Product/Process Change Notice (PCN)	
<input checked="" type="checkbox"/> Major Change <input type="checkbox"/> Minor Change	
PCN Number: PCN_UtLLCR_20250509 Affected Series: WE-LLCR Affected Part Number: 760895641 PCN Date: 2025-02-07 (YYYY-MM-DD) Effective Date: 2025-05-09 (YYYY-MM-DD)	Change Category: <input type="checkbox"/> Equipment/Location <input type="checkbox"/> General Data <input type="checkbox"/> Material <input type="checkbox"/> Process <input checked="" type="checkbox"/> Product Design <input type="checkbox"/> Shipping/Packaging <input type="checkbox"/> Supplier <input type="checkbox"/> Software
Contact: Product Management Phone: +49 (0) 7942 - 945 5001 Fax: +49 (0) 7942 - 945 5179 E-Mail: pcn.eisos@we-online.com	Datasheet Change: <input type="checkbox"/> Yes <input checked="" type="checkbox"/> No Attachment: <input type="checkbox"/> Yes <input checked="" type="checkbox"/> No
DESCRIPTION OF CHANGE: In order to enhance the product reliability, Würth Elektronik will add margin tape to the coil. There will be no change in fit, function, quality or reliability of the product. The new revision of the affected part numbers will be sent out after the previous revision is out

DETAILS OF CHANGE:

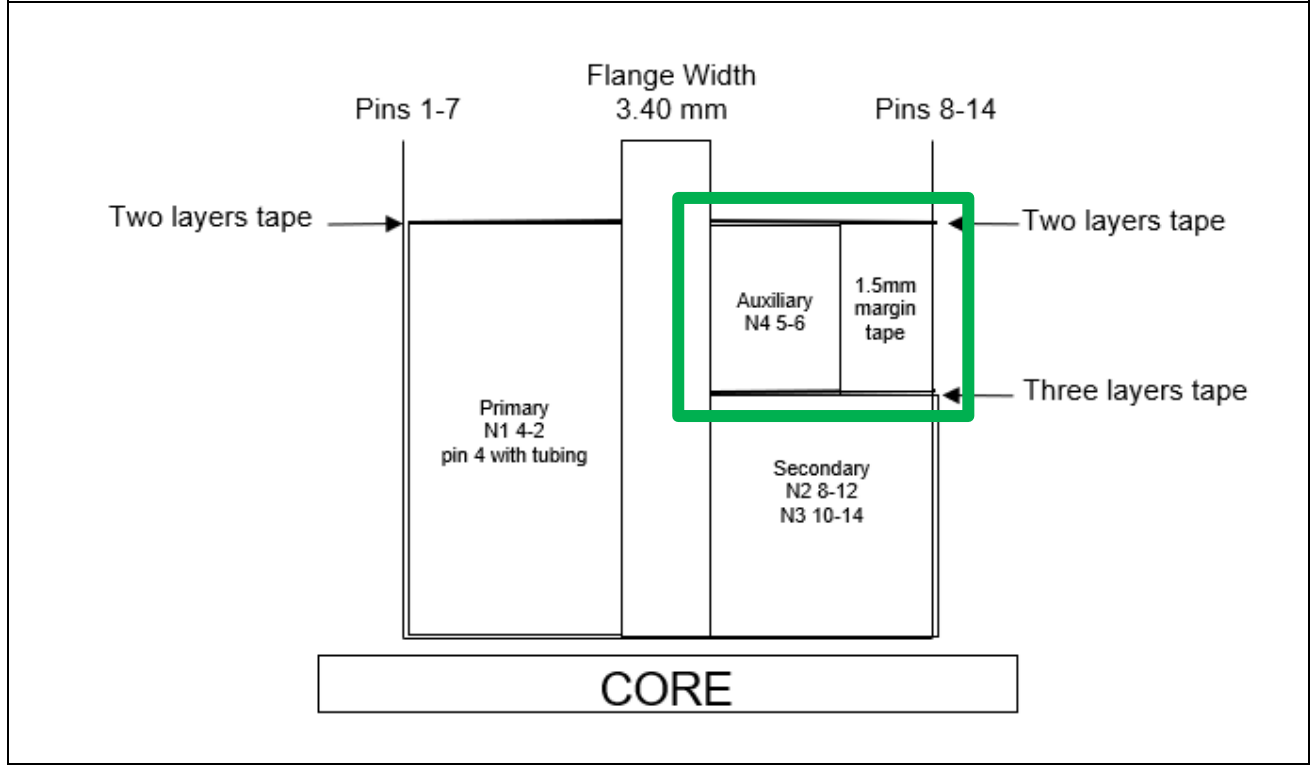
1.5 mm of Jingjiang Yahua Pressure Sensitive Glue Co Ltd Cat. No. WF (E165111) margin tape will be added to the N4 winding on the 8-14 terminal side.
